Burlington Design Advisory Board

Design Advisory Board

Tuesday, December 12, 2023, 3:00 PM

ZP-23-435; 165 Shelburne Street (RL, Ward 5) Champlain Housing Trust, Inc. / Donal Dugan

SOUTH ELEVATION 1/4"=1'-0"

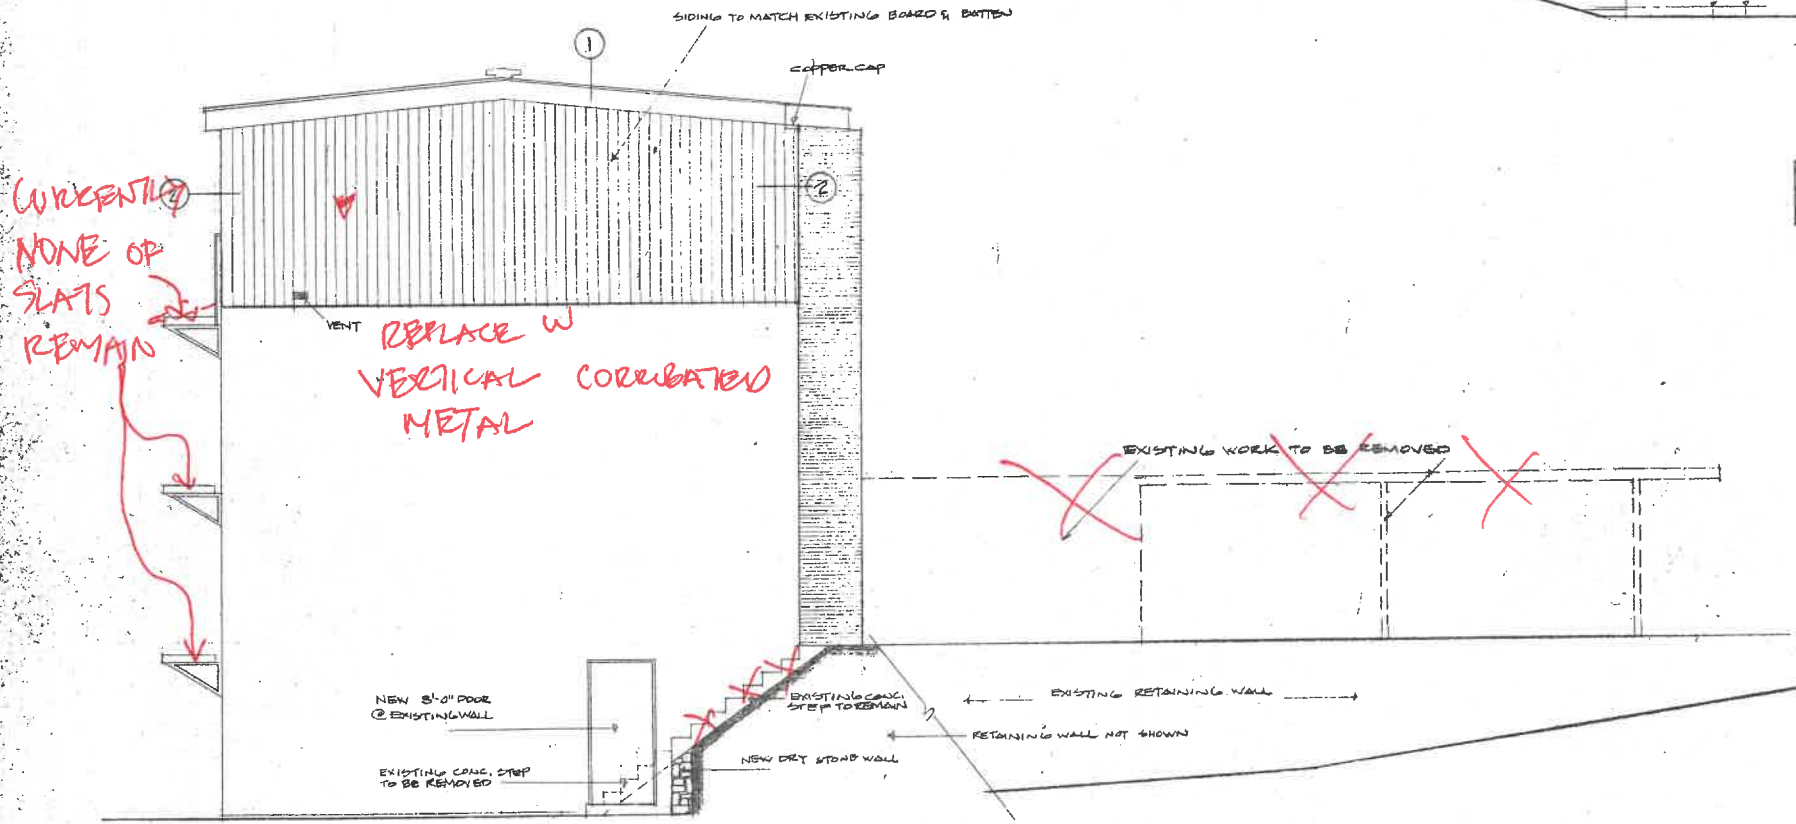
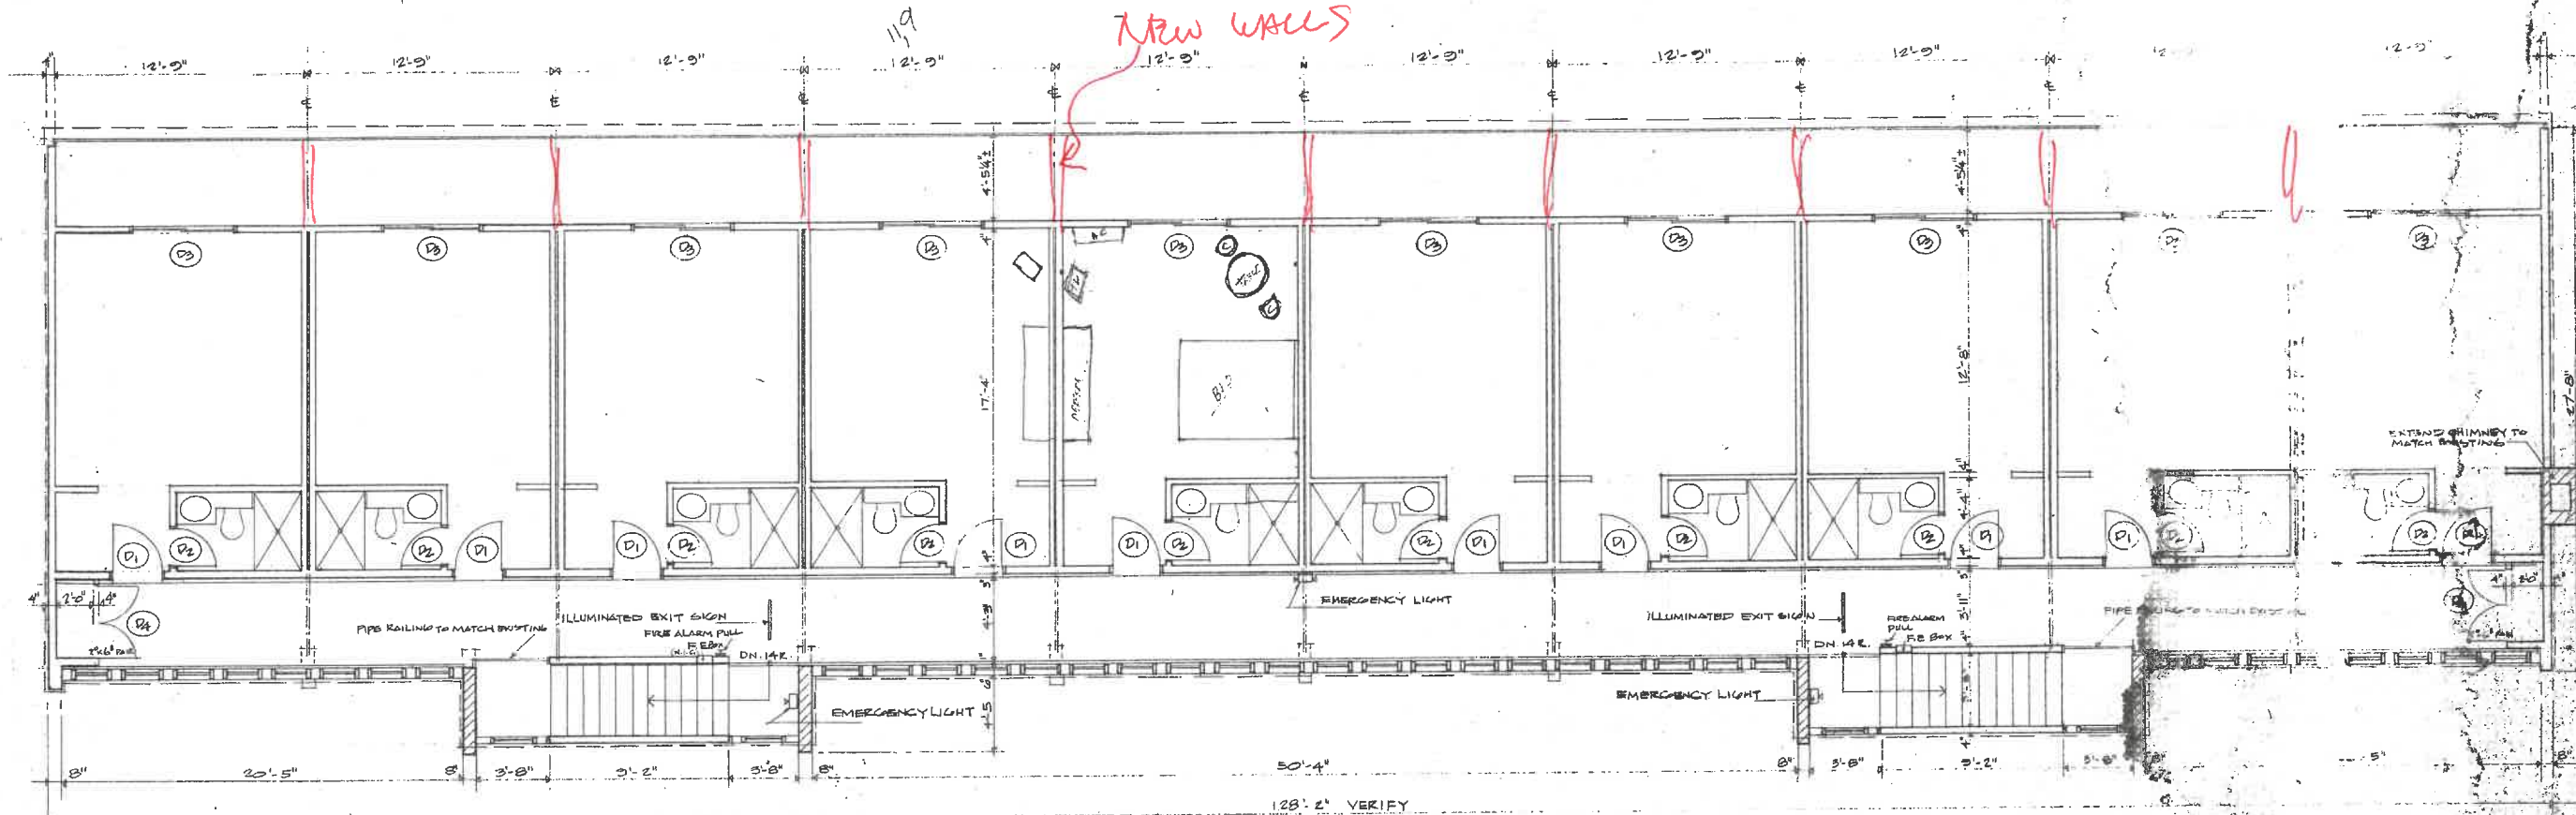
The majority of the changes are similar to others commonly accepted for other projects in the city. The change of the siding on the south side of the motel would be removing material that helps characterize the property and is inconsistent with this criterion.

The new window, changing of doors, and alterations to the porch conforms to the standards for historic buildings. Replacements of the south siding with new corrugated metal will be a change of material from the existing siding.

1. Delete the proposed corrugated metal siding and replace it with a material matching the existing material or is compatible with the existing materials on the historically listed building.

155 165 SHELBURNE ST CHAMPLAIN HOUSING TRUST				CHAMPLAIN PLACE REMODEL				PLAN LEVEL 1											
SHEET TITLE:				NO.				DESCRIPTION				BY				DATE			
DATE:				11/8/2023				SCALE:								SHEET:			
																A-1

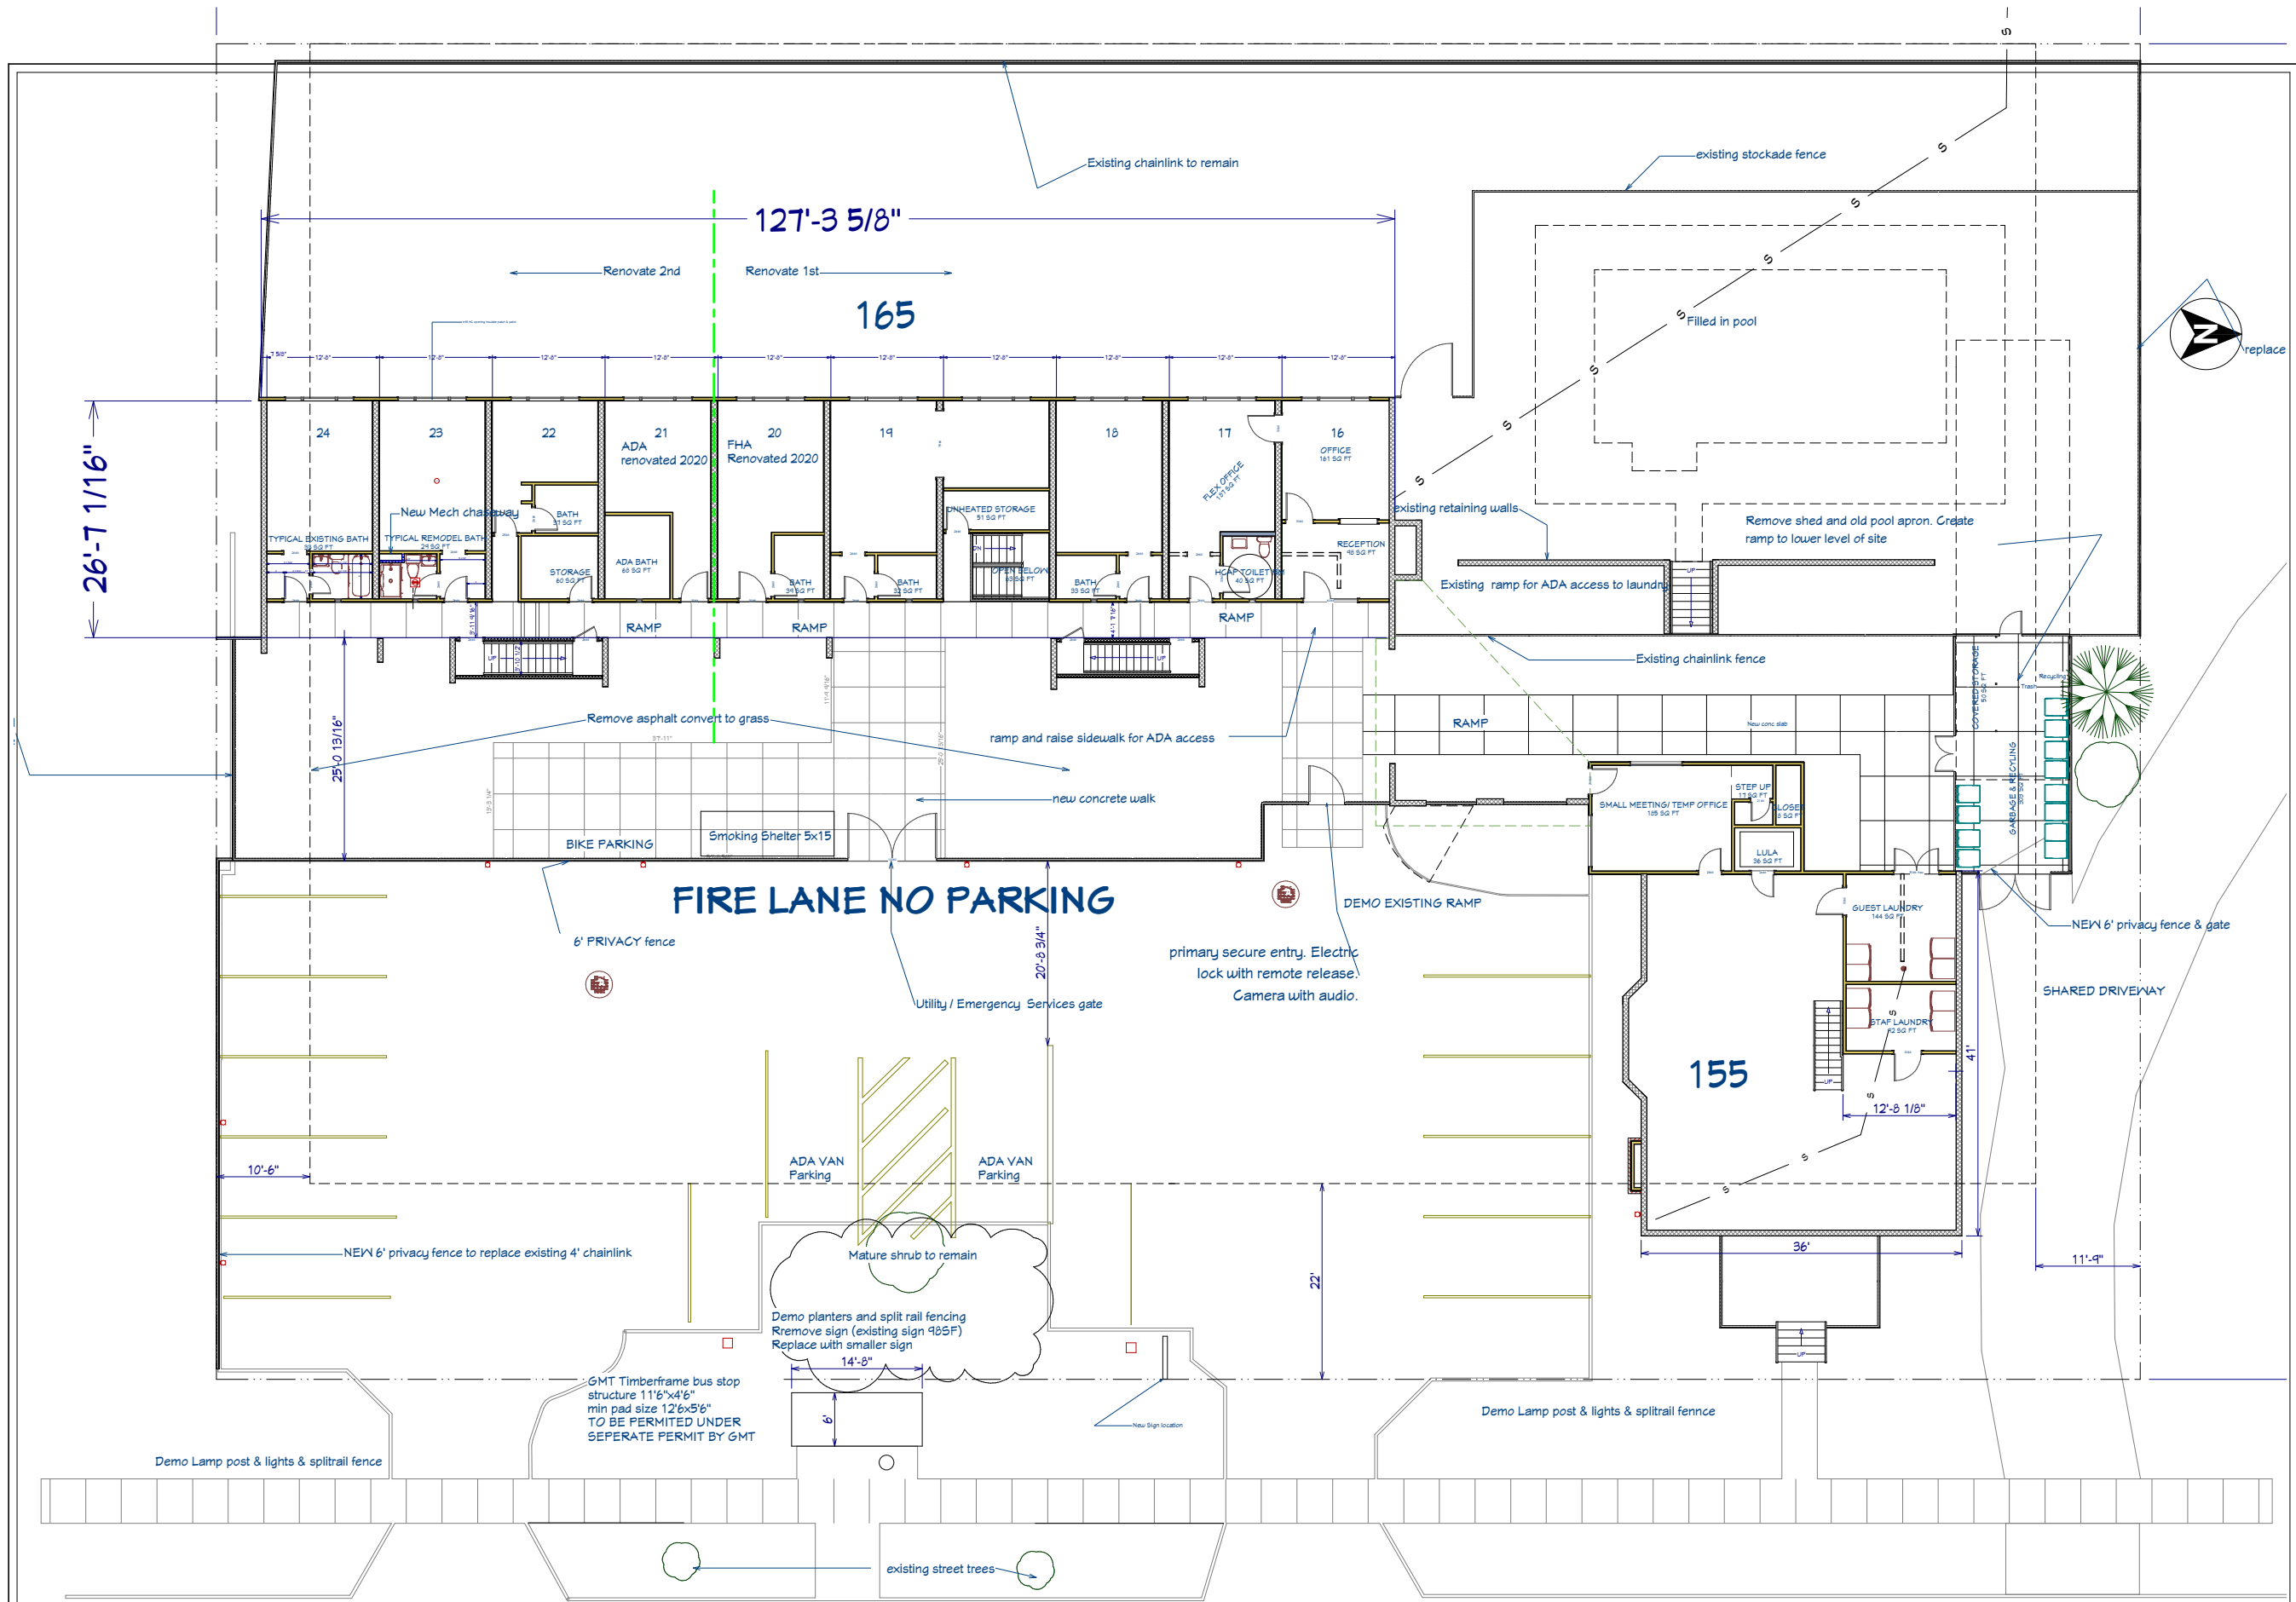
2. The balcony railings should all remain and be repaired if necessary. None of the railings should become solid so you can't see through, and none should be raised to 48" tall. This 48" height is not necessary for safety of not falling over it and the added height makes it very difficult to rescue someone from the balcony during a fire. A solid railing is also not possible to see over or through, making the room gloomy and dark. It will have the effect of all of the top floor rooms feeling like they are basement apartments.

5. Replace all rotting or deteriorated board and batten siding on the top floor with painted wood or composite clapboards to match the exposure of the existing clapboards on the house. Do not use any steel corrugated siding anywhere on this site.

Comments:

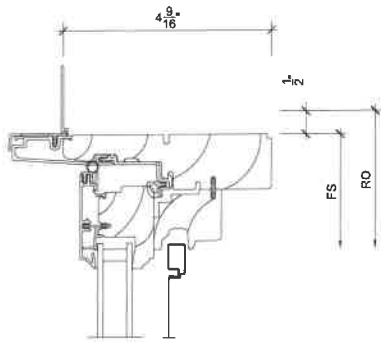
- I had to increase the height to allow us to get to the 5.7 sq. ft egress code.
- Confirm window handing / operation.
- Exact Sizing + Specification To Be Confirmed !!
- Figured as a full frame window, not an insert.
